**ADDENDUM No. 1**

Pine Lake State Park  
Shower Buildings & Cabin Renovation  
Hardin County, IA  
PROJECT NUMBER: 19-02-42-01

April 10, 2020

**SK-4**

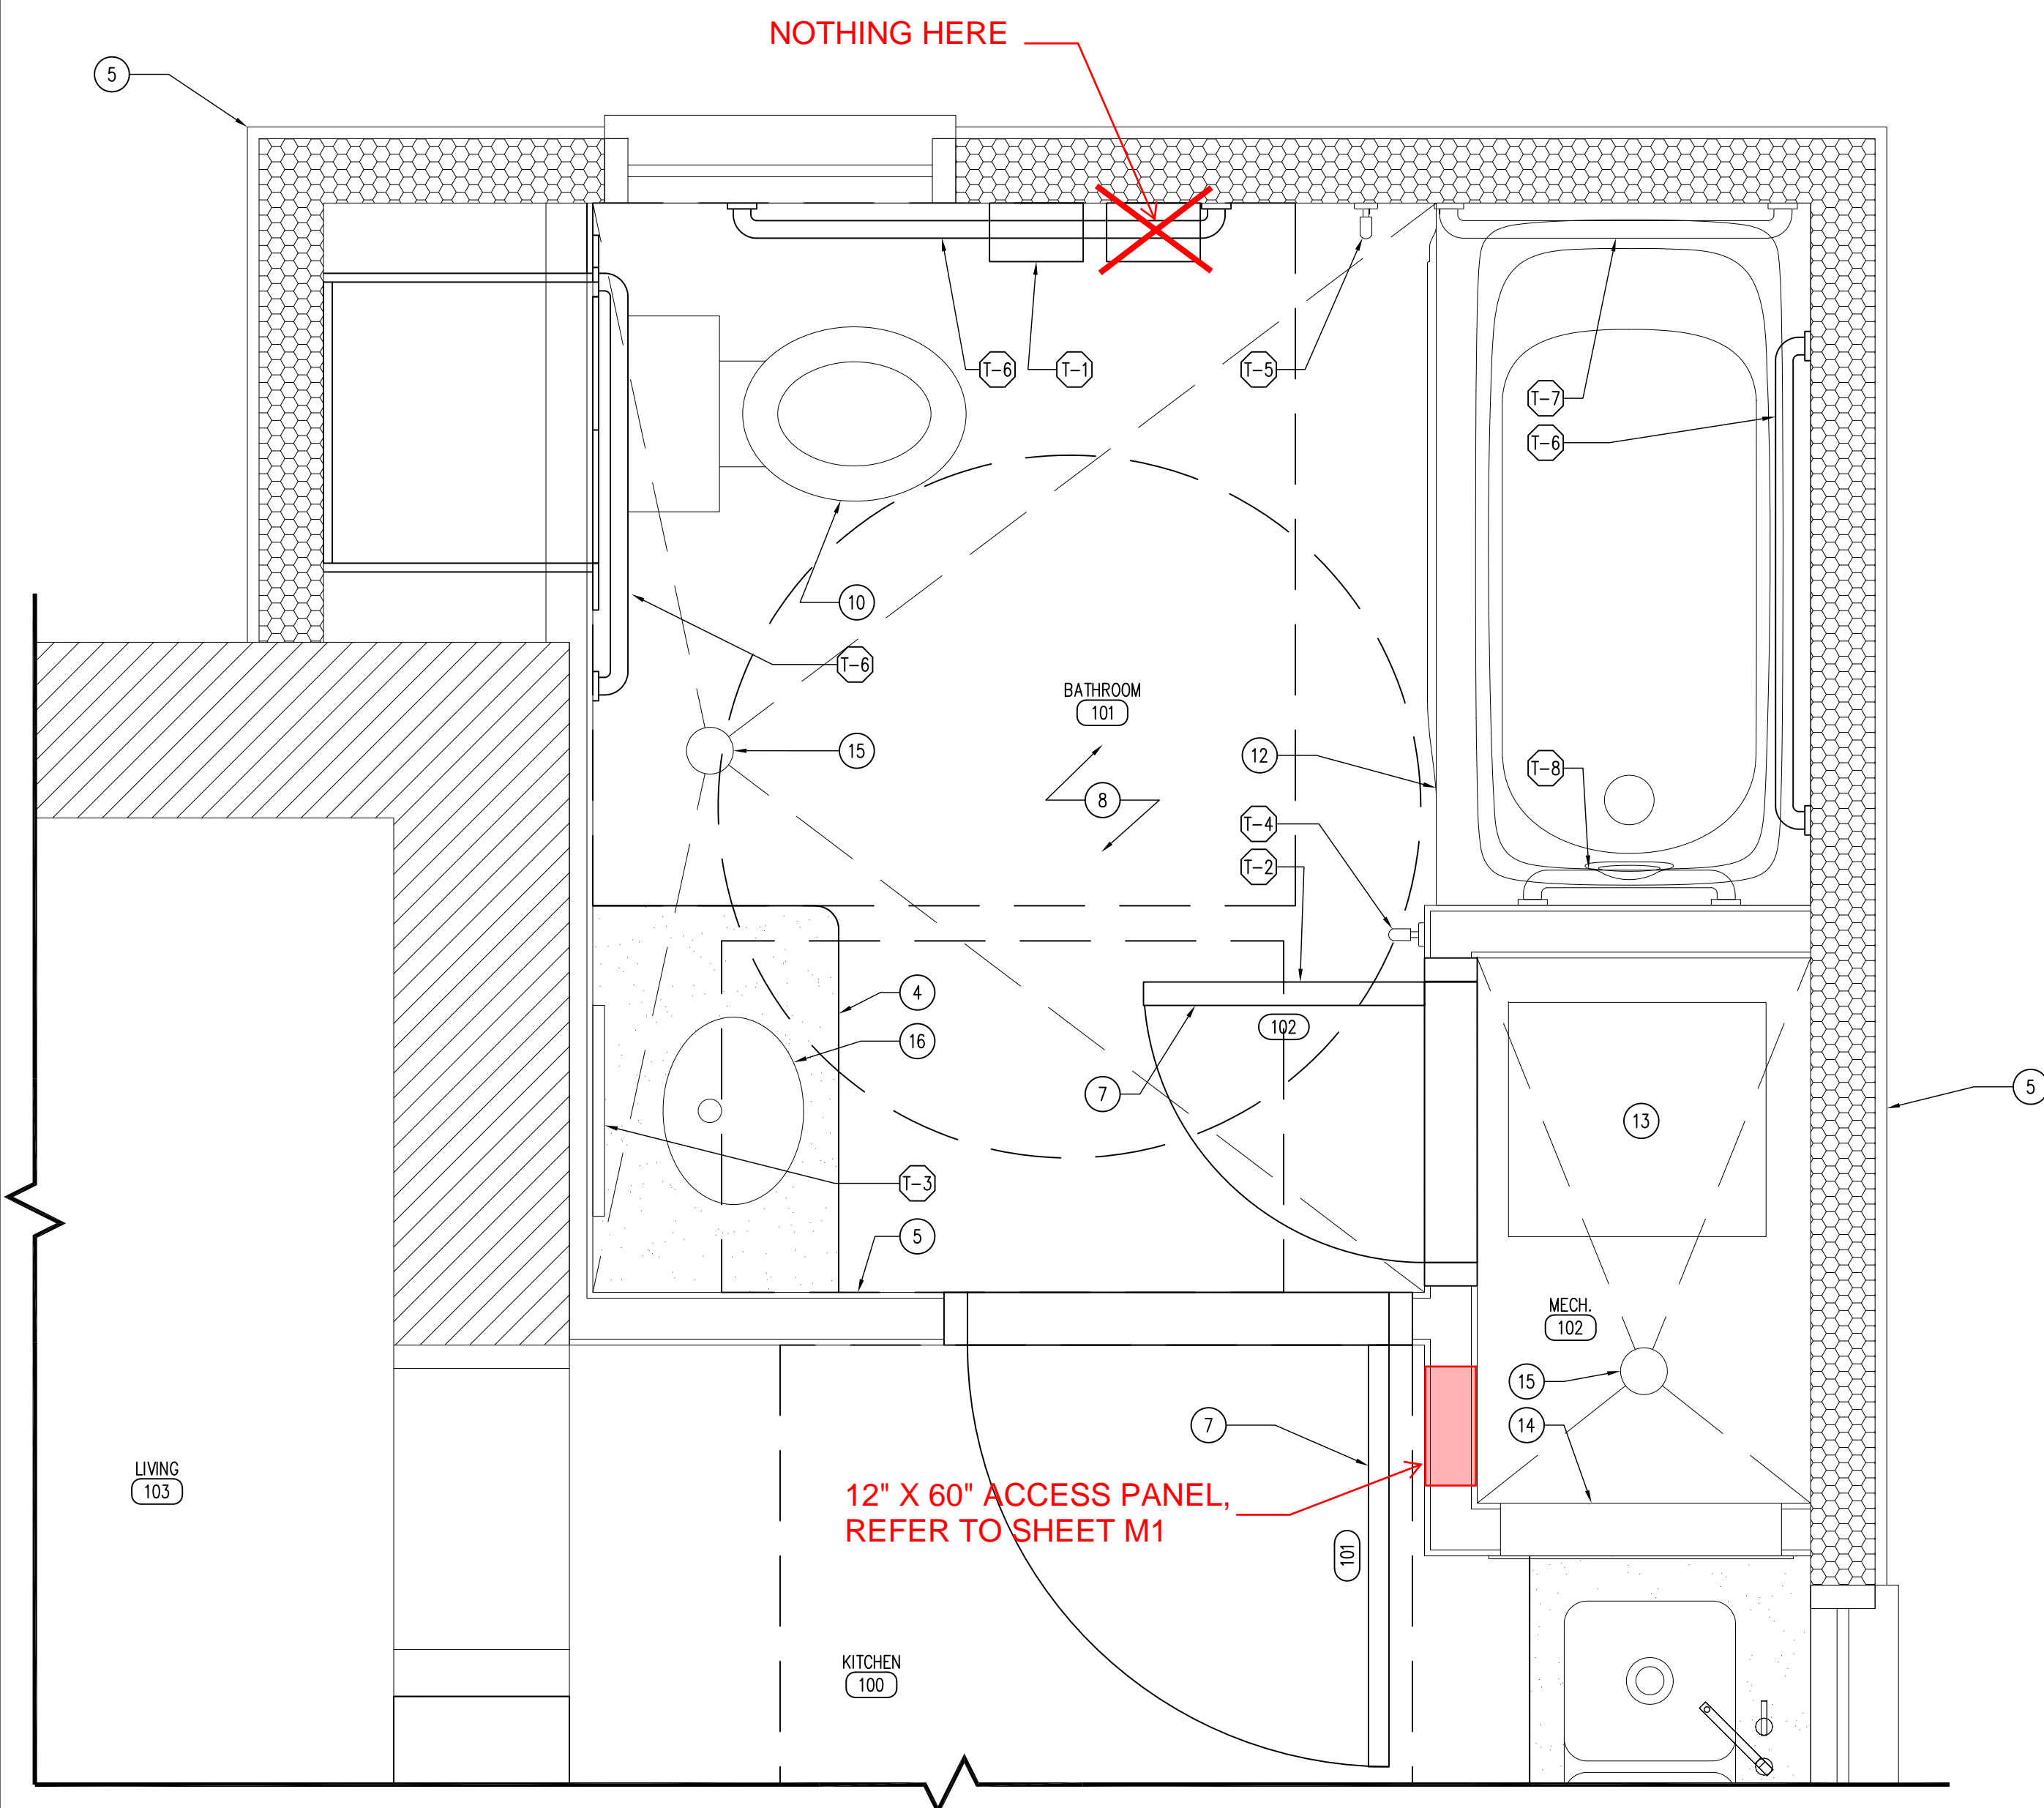
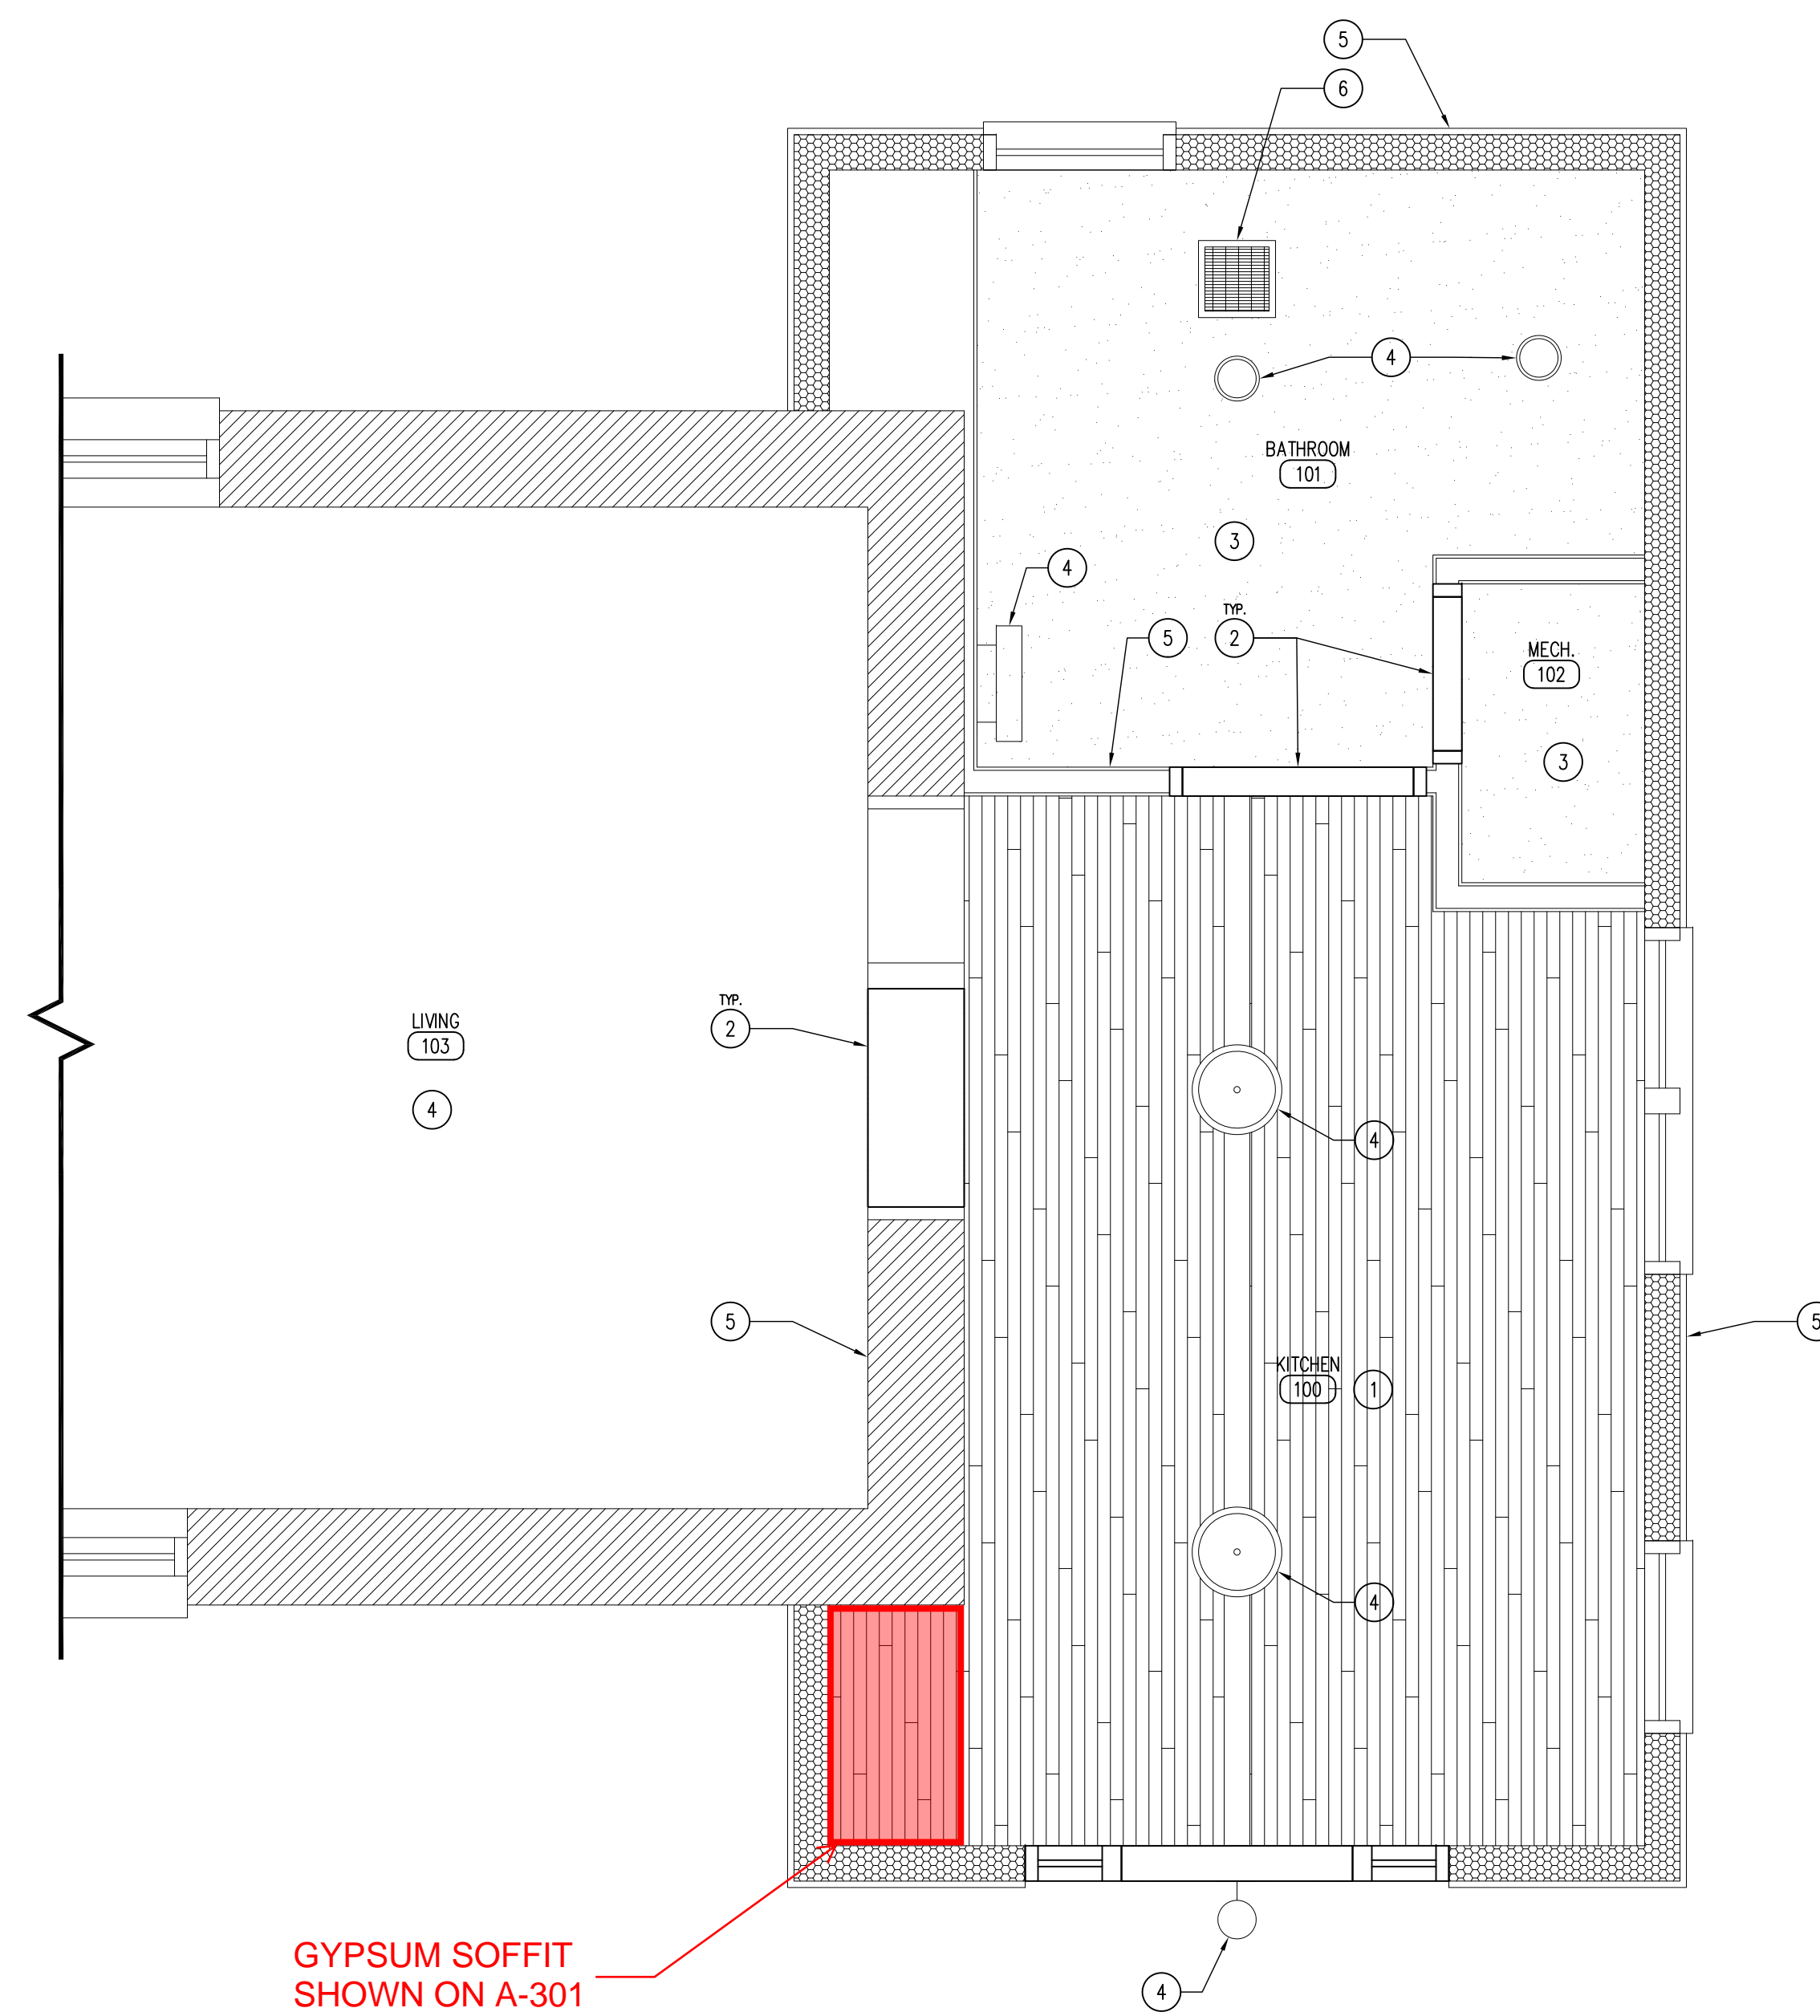
10. Refer to SK-4 for clarification on tissue holder, access panel, and soffit over refrigerator.
11. Plumbing sheet P-3, BFP-1 (backflow preventer), is not required on this project, please disregard this scheduled item.
